NSWC PANAMA CITY

Subject: Responses to University of Florida Comments on the RFI Addendum for AOC 1 and SWMUs 3, 9, and 10 Revision 02 Naval Support Activity Panama City

**RESPONSES TO UNIVERSITY OF FLORIDA COMMENTS DATED MARCH 3, 2008 CONCERNING THE RESOURCE CONSERVATION AND RECOVERY ACT FACILITY INVESTIGATION ADDENDUM FOR AREA OF CONCERN (AOC) 1 AND SOLID WASTE MANAGEMENT UNITS (SWMU) 3, 9, AND 10, REVISION 02, NAVAL SUPPORT ACTIVITY (NSA) PANAMA CITY, PANAMA CITY, FLORIDA (APRIL 22, 2008)**

**Figure 1F. Sign (in distance) located North of SWMU 3.**

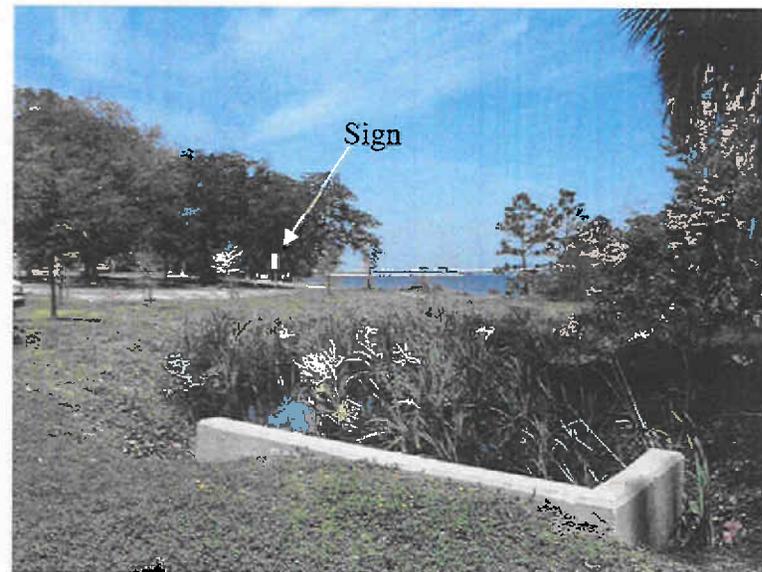
Risks for future residents were not re-evaluated and are assumed to be the same as calculated in 1996 (see page 5-4). The report contends that if land use changes to permit residential scenarios in the future, contaminant concentrations will likely have changed and human health risks would need to be re-evaluated. This is reasonable, but the conclusion should not be lost that this SWMU is unsuitable for unrestricted land use.

Nevertheless, the Statement of Basis for SWMU 3 requires the use of land use controls to prevent intrusive activities and unacceptable levels of exposure and the corrective measures implementation plan imposes land use controls to accomplish this objective. Signs currently posted at SMWU 3 also serve to advise any visitors to avoid contact with soil and water. One of these signs, located north of the SWMU, is visible in Figure 1F, slightly left of center.

| FIGURE 2A       | 0    |

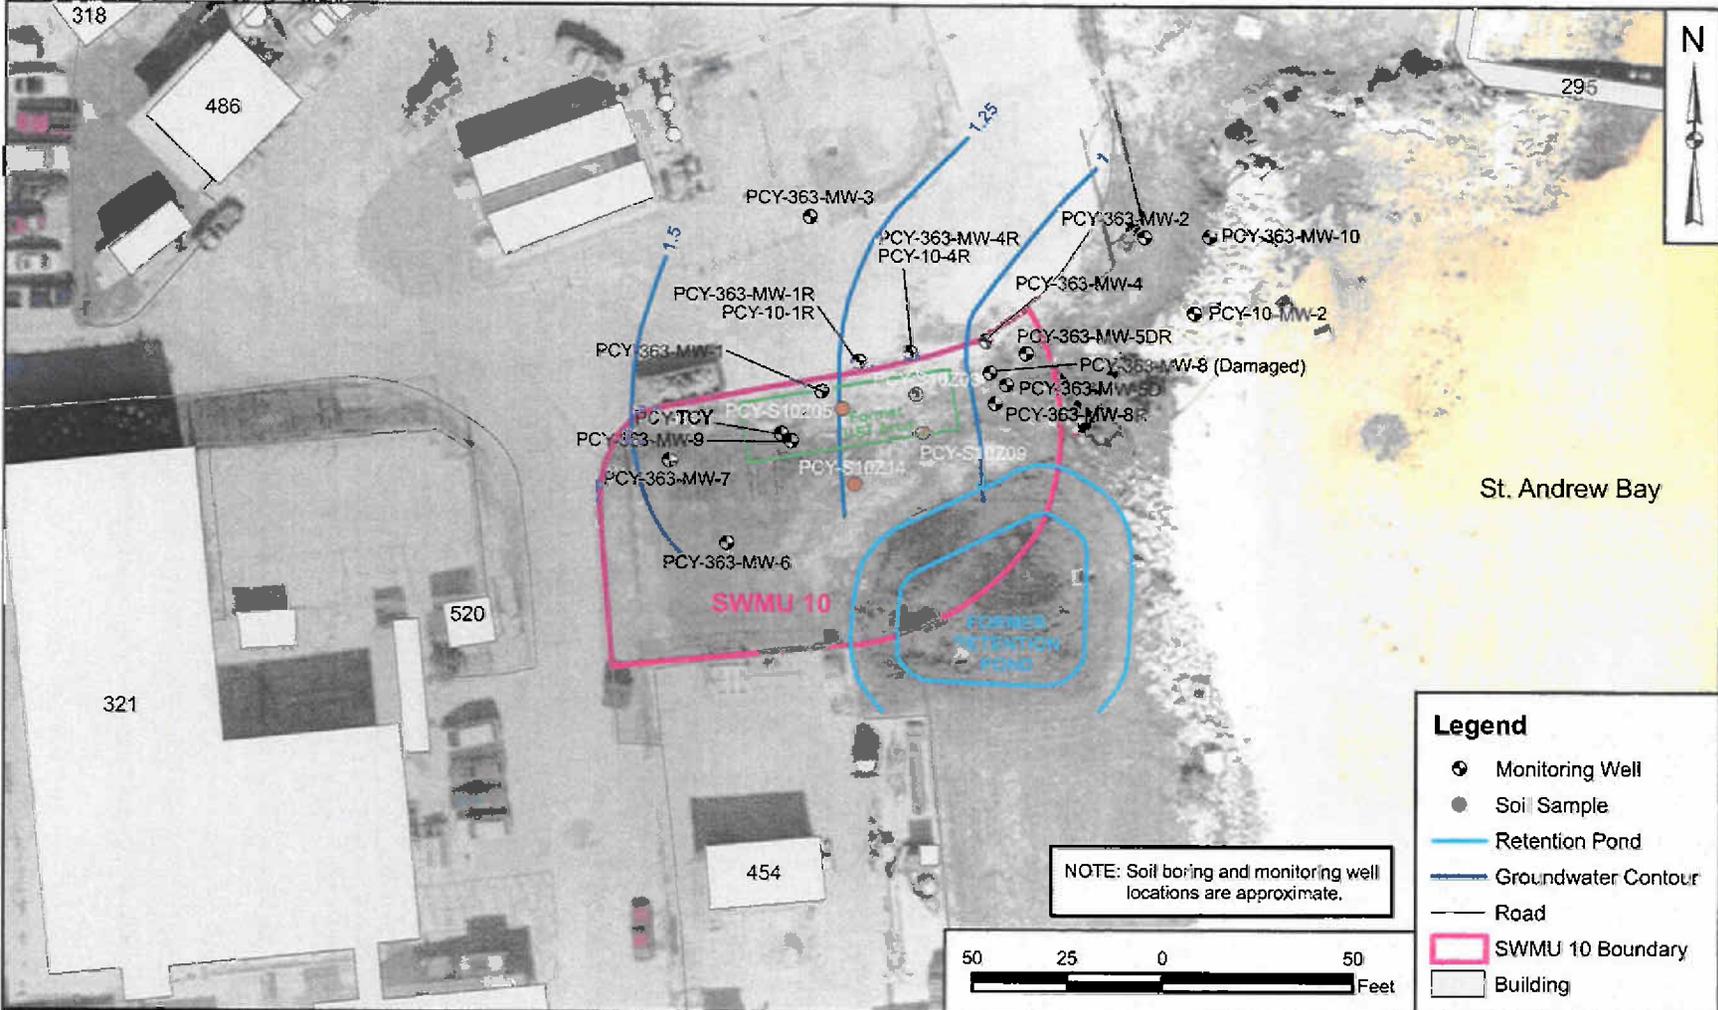
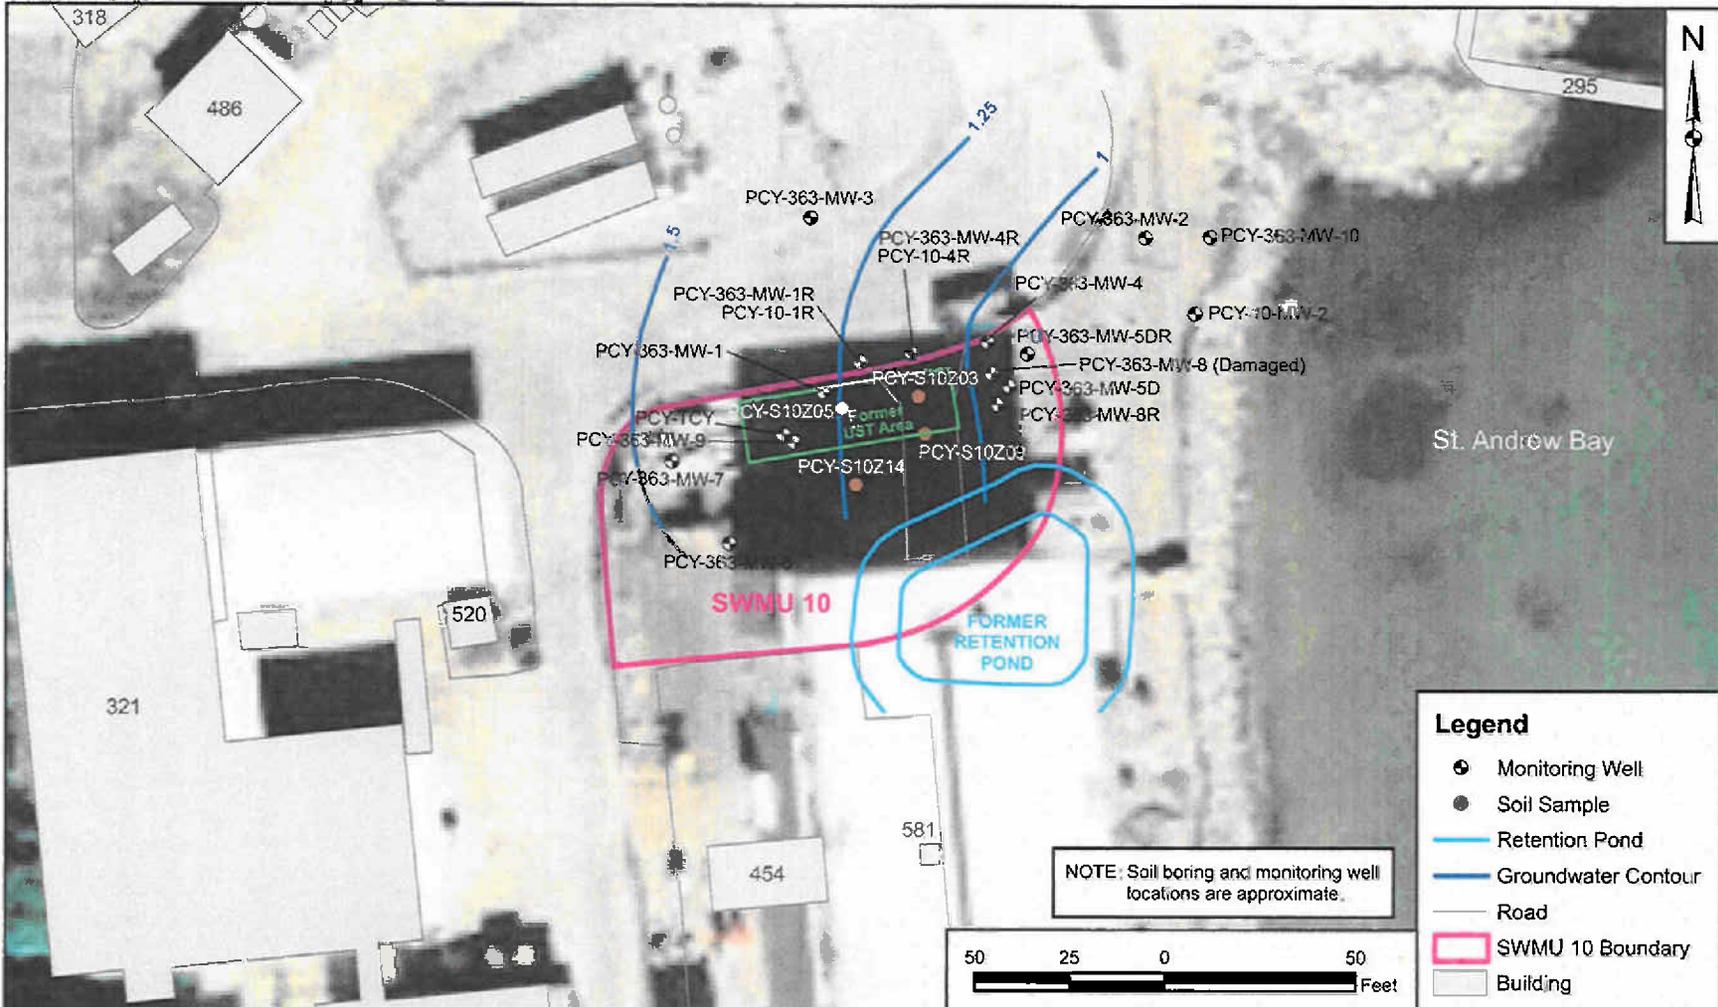
There are a number of contaminants in groundwater at concentrations that exceed their groundwater cleanup target levels (GCTLs) or surface water cleanup target levels (SWCTLs). The Addendum concludes correctly that "adverse health effects would be expected if groundwater was used as a domestic drinking water supply." The Addendum also states, "The SWCTL exceedence, however, were generally slight and no adverse impact to surface water is anticipated because of natural attenuation. We agree that natural attenuation will be helpful in minimizing impacts associated with the discharge of contaminated groundwater to surface water. However, the discharge of concentrations that exceed the SWCTL is not allowed under Chapter 62-780, FAC.

Figures 2A and 2B show the locations of wells at SWMU 10 with the groundwater level contours. Figure 2B is the most recent available aerial photograph. The exceedances identified above occurred at well PCY-363-MW-1R, which is adjacent to the former contaminant source (oil and bilge water released to soil), and therefore represents the worst case or near worst case groundwater conditions. Well PCY-363-MW-1R is located approximately 100 feet upgradient of St. Andrew Bay, the closest surface water body to SWMU 10. This well is far enough from the bay and the measured concentrations are close enough to SWCTLs that natural attenuation processes are expected to reduce the concentrations to levels less than the SWCTLs by the time the groundwater reaches the bay. This is explained further below.

| FIGURE 3B       | 0    |

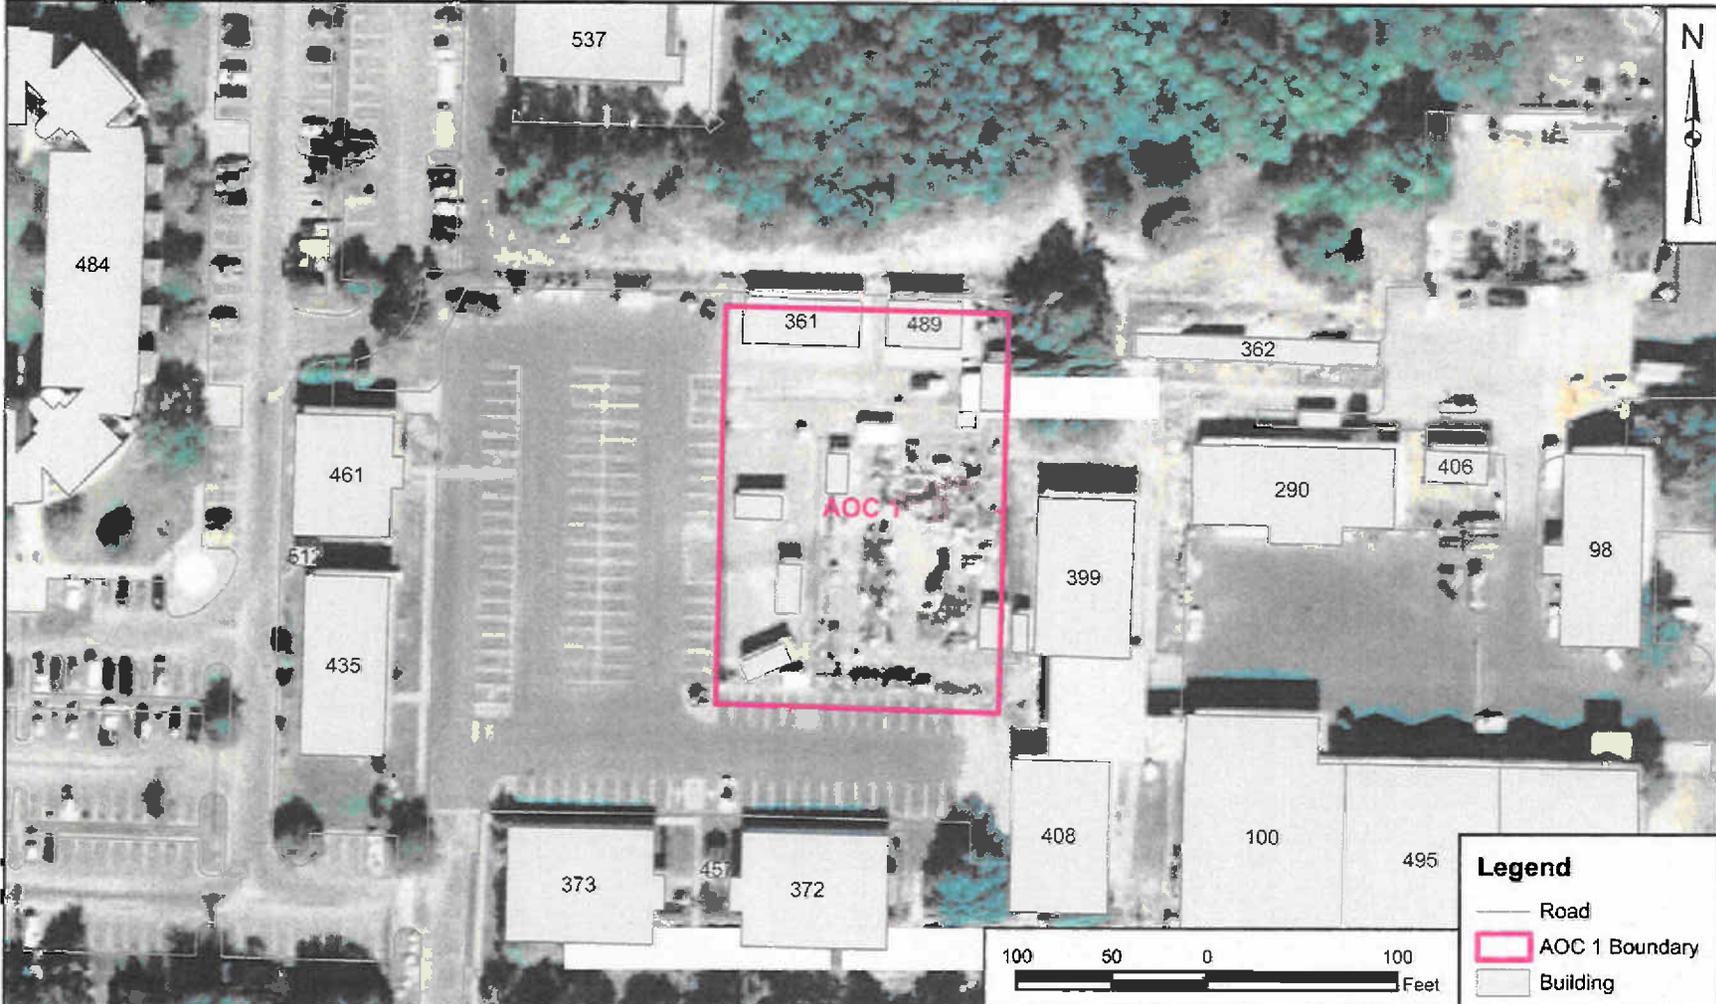
As with SWMU 10, the re-evaluation of soil concentration data for AOC1 also indicates the presence of contamination exceeding residential and commercial/industrial cleanup levels.

Comment has been noted. AOC 1 is currently completely paved and covered with Building 399, thus eliminating any direct exposure pathway for human receptors. This can be seen in Figures 3A and 3B. Although the AOC 1 appears to have a color similar to soil in these figures, it is covered with concrete and asphalt pavement and is used as an equipment storage area. The corrective measures implementation plan for AOC 1 will require enforcement of land use controls on the AOC 1 property to prevent unacceptable risks to current or future receptors. Signs currently posted at AOC 1 advise visitors against having contact with soil or water.
